Appl. No. 10/718,301
Amdt. dated 10/12/2005
Reply to Office Action of 07/12/2005

IN THE DRAWINGS:

FIG. 2

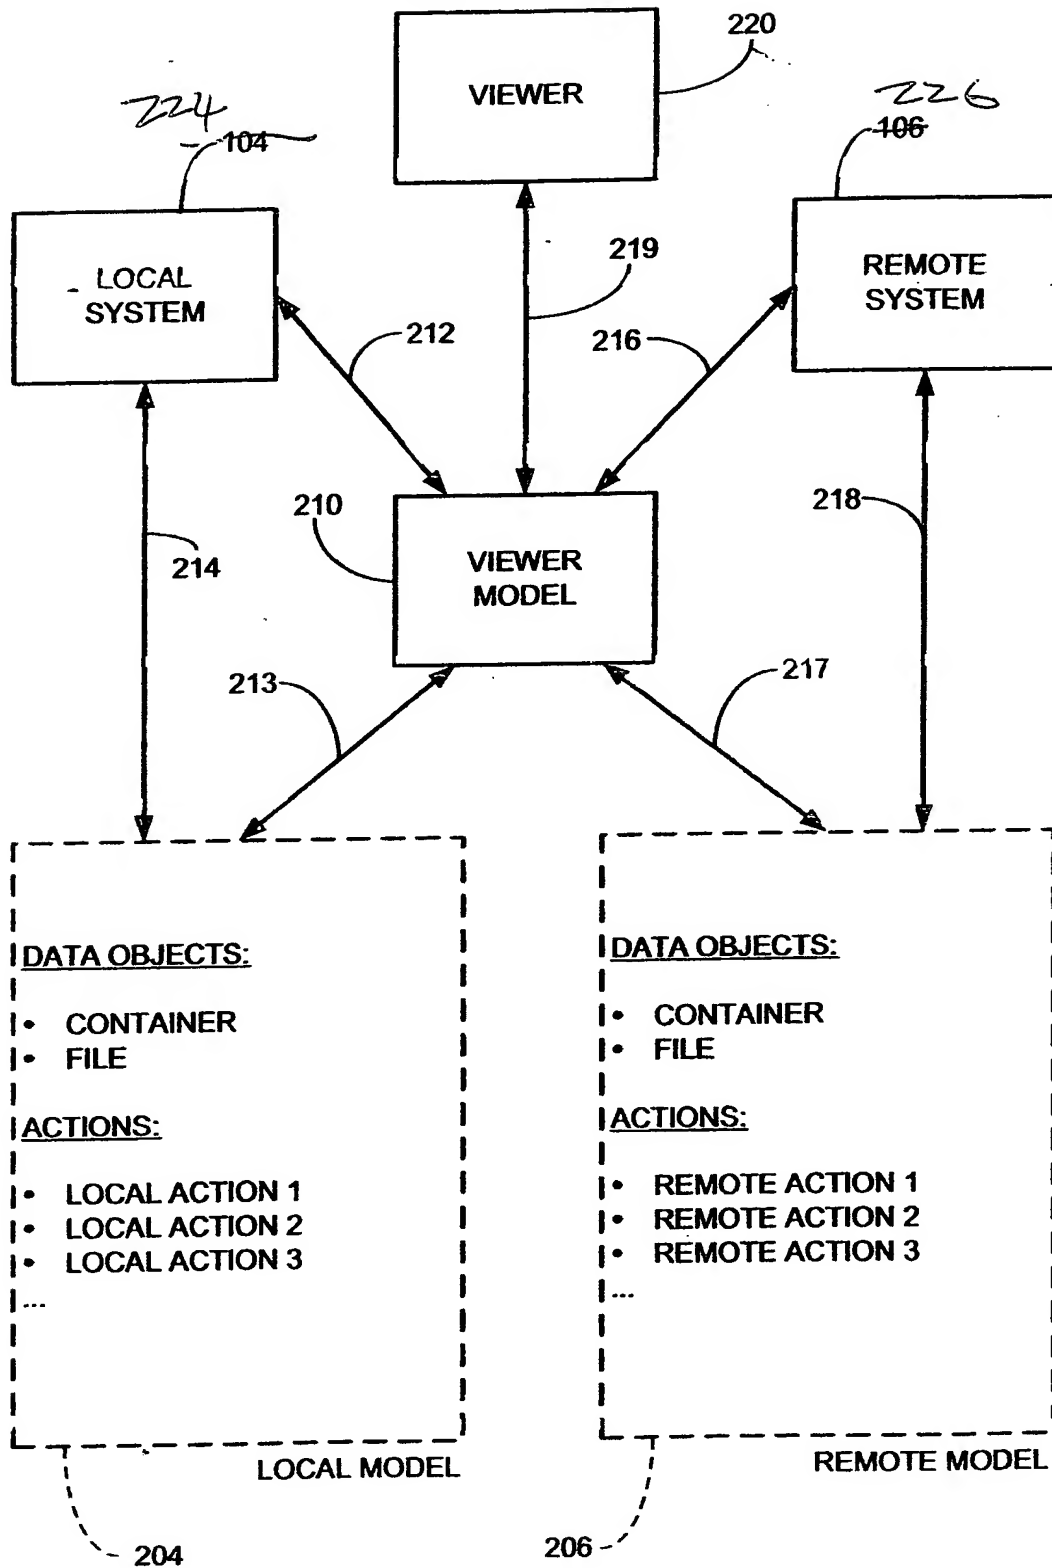
Please replace reference numerals 104 and 106 with reference numerals 224 and 226, respectively, and as shown in RED in the attached corrected Drawing figure.

Fig. 2 has been amended to replace reference numerals 104 and 106 with reference numerals 224 and 226, respectively.
